**ADMINISTRATIVE SITE DEVELOPMENT PLAN REPORT & DECISION**

<b>REPORT DATE:</b>	April 13, 2015
<b>Project Name:</b>	Highland Oasis
<b>Owner/Applicant:</b>	Jennifer Zhou, 12419 NE 140 <sup>th</sup> St, Kirkland, WA 98034
<b>Contact:</b>	Andrew Wang, 12419 NE 140 <sup>th</sup> St, Kirkland, WA 98034
<b>File Number:</b>	LUA14-000335, SA-A
<b>Project Manager:</b>	Jill Ding, Senior Planner
<b>Project Summary:</b>	Application to construct two 2,688 square foot duplexes on an 11,180 square foot site zoned R-14 (residential 14 dwelling units per acre). The applicant has submitted a request for the approval of one additional dwelling unit per the criteria set forth under RMC 4-9-065 Density Bonus Review. To qualify for Bonus Density, the applicant has proposed to provide vehicular access to the units via the existing alley to the rear of the property and provide active recreational amenities on site. 1.5 feet of right-of-way dedication would be provided along Jefferson Ave SE. The site is located within an Aquifer Protection Area

<b>Project Location:</b>	1419 Jefferson Ave NE
<b>Site Area:</b>	11,180 sf (0.26 ac)

ELEVATIONS

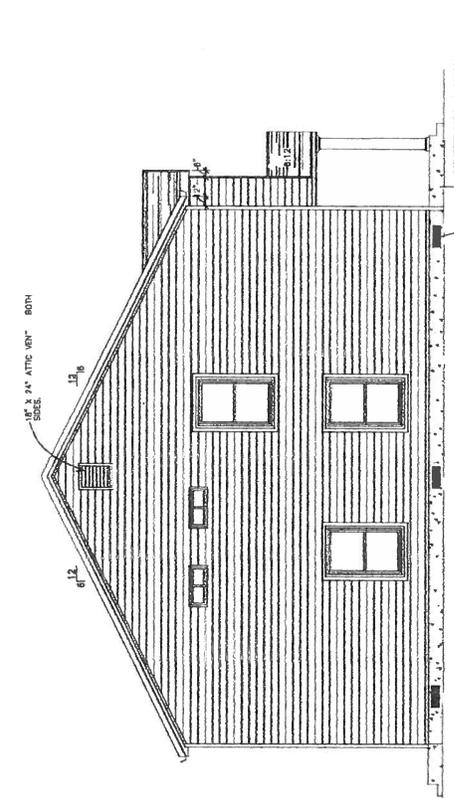
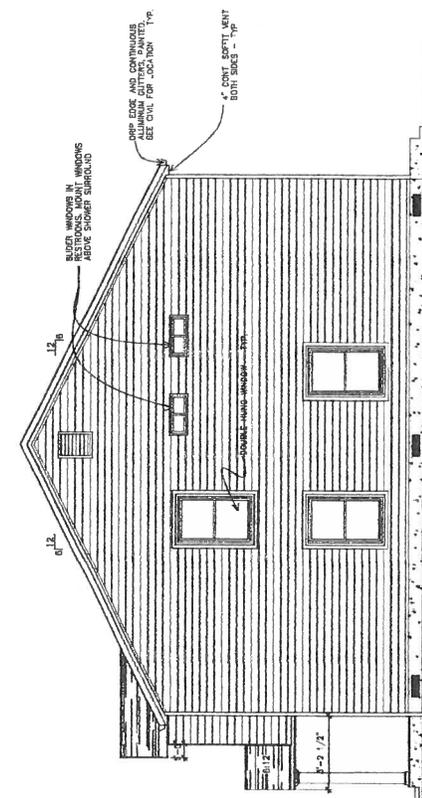
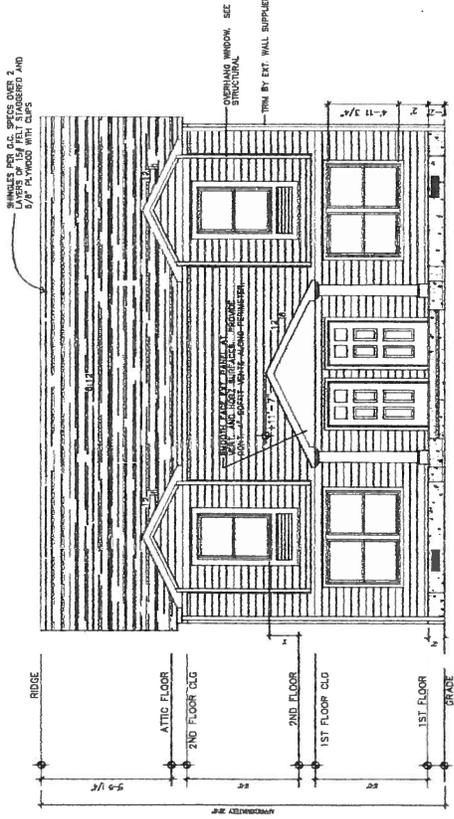
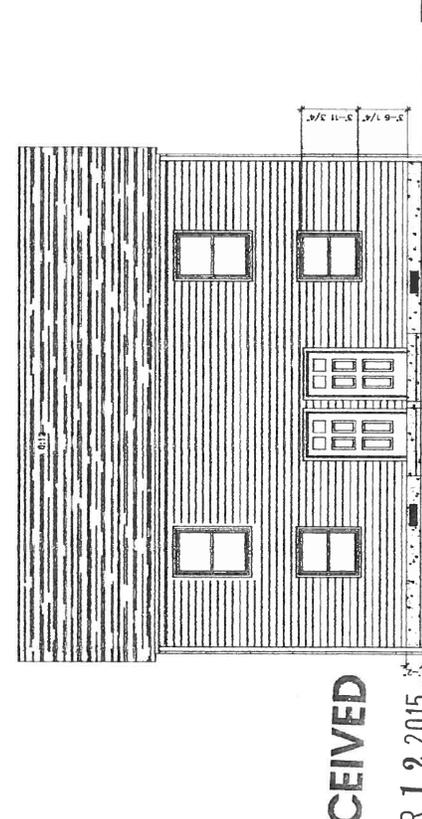
Partially Compliant	<p><b>Standard:</b> The following is required: Eaves shall be at least twelve inches (12") with horizontal fascia or fascia gutter at least five inches (5") deep on the face of all eaves.</p> <p><b>Staff Comment:</b> Based on the elevations submitted, it appears that some eaves are less than 12 inches and some eaves are missing the 5-inch minimum fascia. Staff recommends, as a condition of approval, that revised building elevations be submitted at the time of building permit review. The revised elevations shall show the minimum 12-inch eaves and 5-inch minimum fascia required. The revised building elevations shall be submitted for review and approval by the Current Planning Project Manager.</p>
---------------------	---

<p>minimum 3 ½ inch minimum requirement. Staff recommends, as a condition of approval, that revised building elevations be submitted at the time of building permit review. The revised elevations shall include minimum 3 ½ inch trim around all windows and doors. The revised elevations shall be submitted to the Current Planning Manager for review and approval.</p>
<p><b>8. MATERIALS AND COLOR: The use of a variety of materials and color contributes to the sense of diversity of housing stock in the community.</b>  <b>Guidelines:</b> A diversity of materials and color shall be used on homes throughout the community. A variety of materials that are appropriate to the architectural character of the neighborhood shall be used. A diverse palette of colors shall be used to reduce monotony of color or tone.</p>	
<p><b>Partially Compliant</b></p>	<p><b>Standard:</b> All of the following are required:</p> <ol style="list-style-type: none"> <li>1. Acceptable exterior wall materials are: wood, cement fiberboard, stucco, stone, and standard sized brick three and one-half inches by seven and one-half inches (3 1/2" x 7 1/2") or three and five eighths inches by seven and five-eighths inches (3 5/8" x 7 5/8"). Simulated stone, wood, stone, or brick may be used to detail homes, and</li> <li>2. When more than one material is used, changes in a vertical wall, such as from wood to brick, shall wrap the corners no less than twenty-four inches (24"). The material change shall occur at an internal corner or a logical transition such as aligning with a window edge or chimney. Material transition shall not occur at an exterior corner, and</li> <li>3. Multiple colors on buildings shall be provided. Muted deeper tones, as opposed to vibrant primary colors, shall be the dominant colors. Color palettes for all new structures, coded to the home elevations, shall be submitted for approval.</li> <li>4. Gutters and downspouts shall be integrated into the color scheme of the home and be painted, or of an integral color, to match the trim color.</li> </ol> <p><b>Staff Comment:</b> No information regarding colors or exterior wall materials was submitted with the site plan review materials. Staff previously recommended, as a project condition, that information regarding colors be provided at building permit review. Staff further recommends, as a condition of approval, that proposed exterior wall materials be submitted at the time of building permit review, demonstrating compliance with the requirements of the Residential Design Standards. Exterior wall materials of the proposed structures are subject to the review and approval of the Current Planning Project Manager.</p>

9. Revised building elevations shall be submitted at the time of building permit review. The revised elevations shall show the minimum 12-inch eaves and 5-inch minimum fascia required, by RMC 4-2-115F. The revised building elevations shall be submitted for review and approval by the Current Planning Project Manager, prior to Building Permit issuance.

10. Revised building elevations shall be submitted at the time of building permit review. The revised elevations shall include minimum three and a half inch (3 ½") trim around all windows and doors. The revised elevations shall be submitted to the Current Planning Manager for review and approval, prior to Building Permit issuance.
